NIKKEI MEMORIAL PHASE II
Addendum No. 4
January 16, 2009

NOTICE TO ALL PLAN HOLDERS

Scale as shown Purlin Geometry in Section 1/4" = 1' Cascade Crest Designs

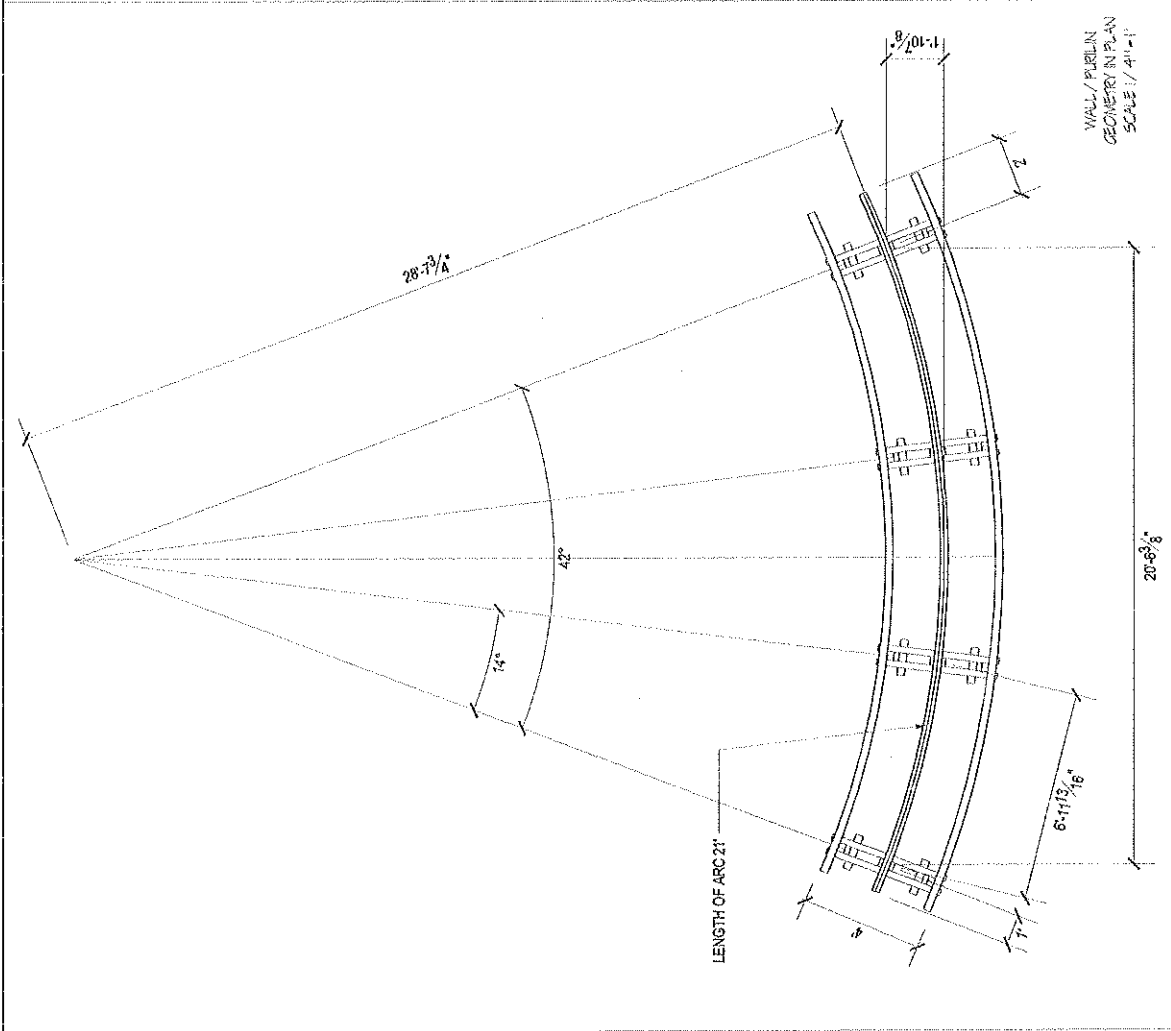
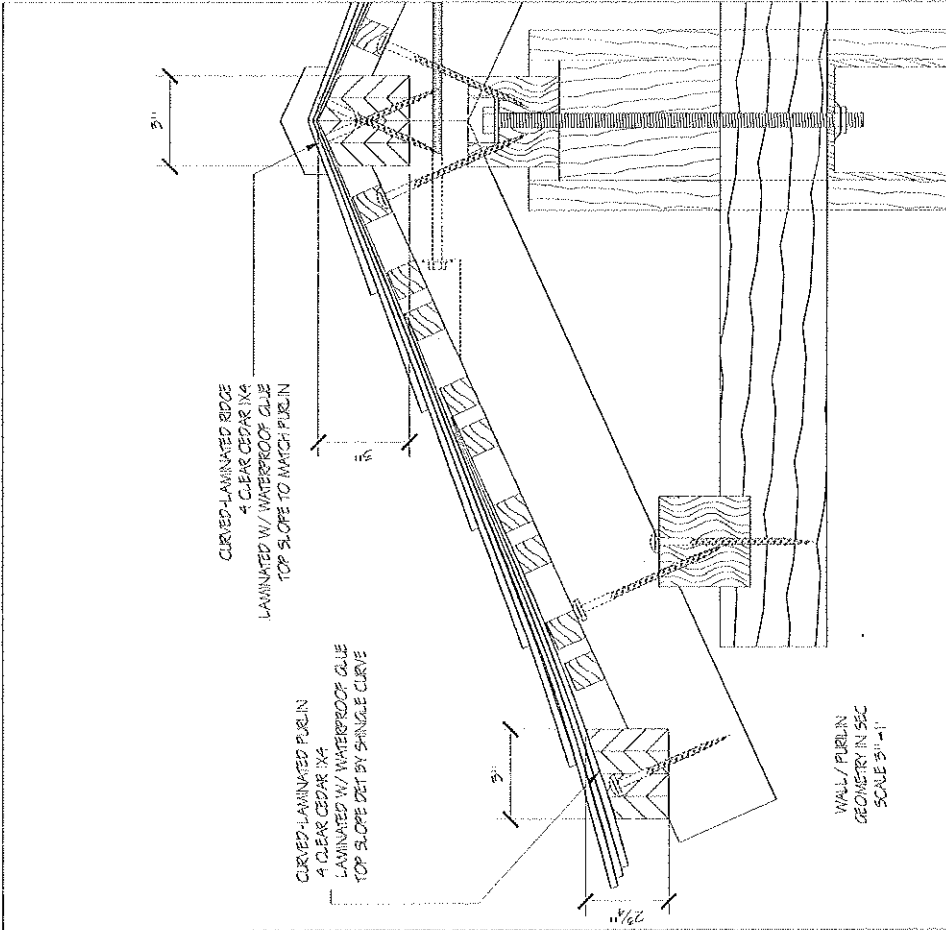
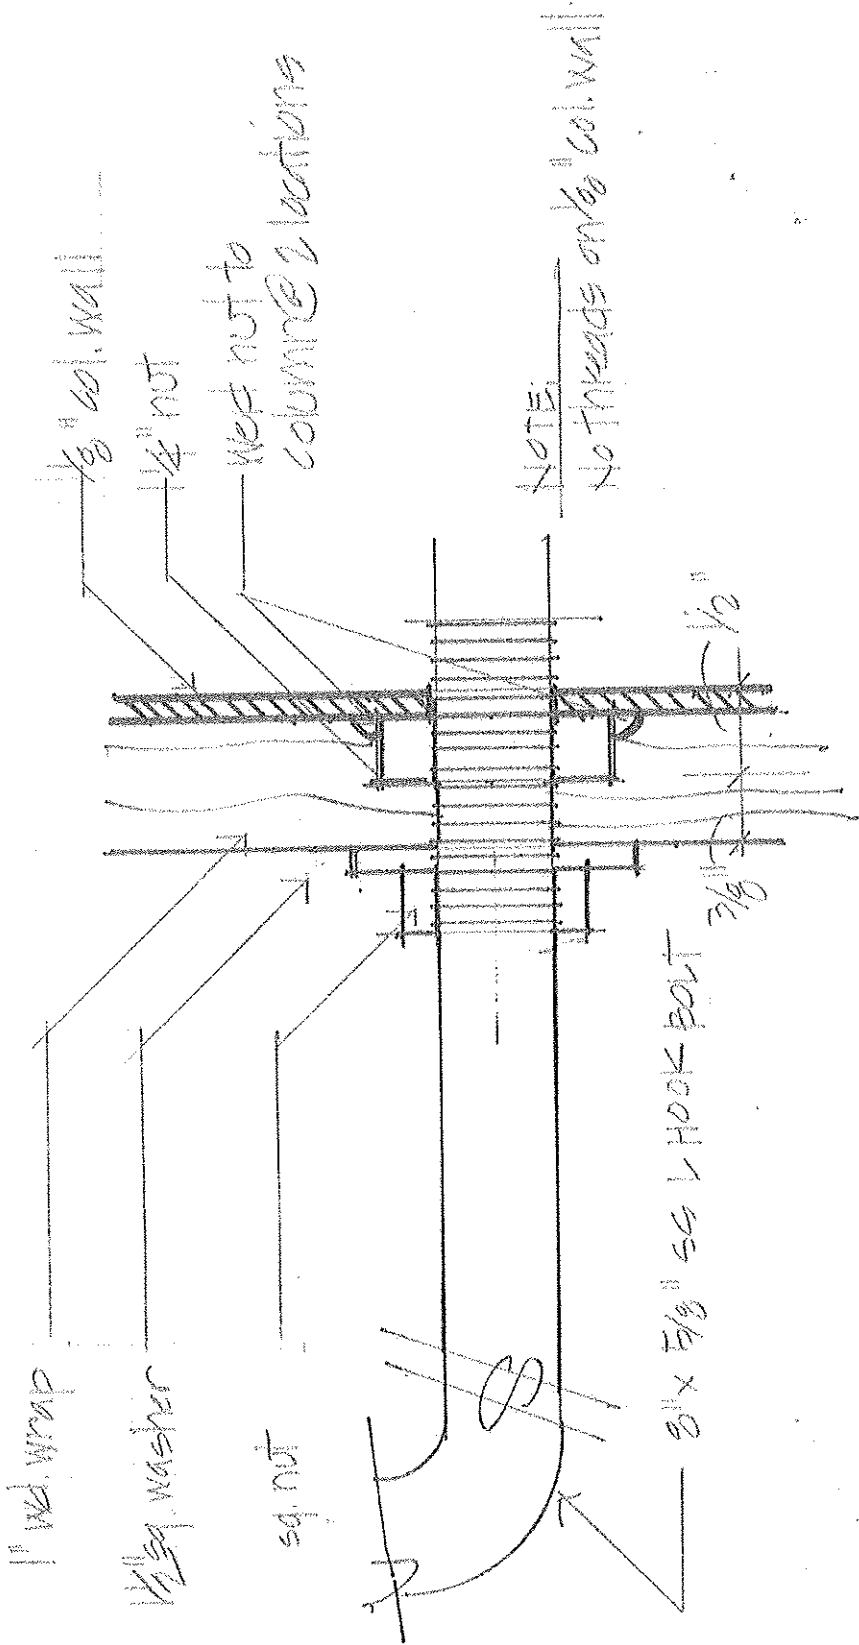
- 1. Page L5.1 Detail 2 additional cross section information is provided in attached drawing.**
- 2. Page L5.2 Detail 1 additional cross section information is provided in attached drawing**
- 3. Page L4.5 Detail #10 the 4" pipe is corrected to #40 galvanized to be consistent with section 055000 section 2.3 E.**
